# SERVICE BULLETIN

Classification: EL20-019	Reference: NTB20-061	Date: August 31, 2020
-----------------------------	-------------------------	--------------------------

## TRAFFIC SIGN RECOGNITION OR LANE DEPARTURE WARNING MALFUNCTION DISPLAYED AND MIL ON WITH DTC C2503-54 AND/OR C1F6B-54 STORED

**APPLIED VEHICLES:** 2020 Sentra (B18)  
**APPLIED DATE:** Built before May 29, 2020

Figure 2

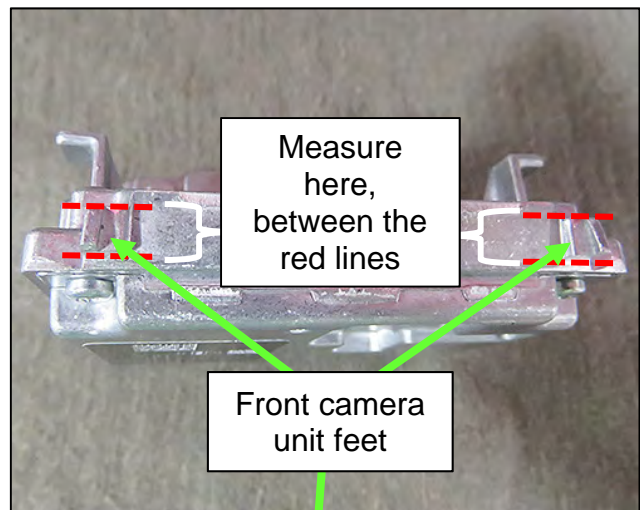
2. Measure the feet of the front camera unit with an appropriate tool and write the measurements on the repair order.
  - This will provide a starting measurement to compare to as material is removed.

**NOTE:** If the bottom of the feet have already had material removed, skip to step 6 to reprogram the lane camera.

Figure 3

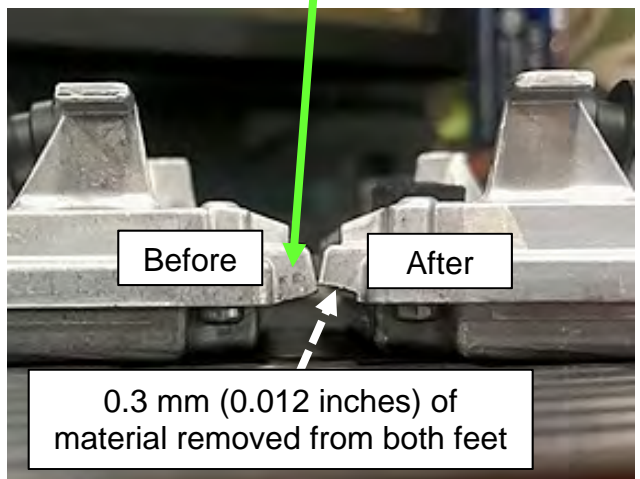
3. Remove 0.3 mm (0.012 inches) of material off of the bottom of both feet.
  - Carefully remove material with a suitable tool such as a file.
  - A dial caliper, or equivalent measuring instrument, can be used.

**NOTE:** Only one foot is shown in Figure 3.
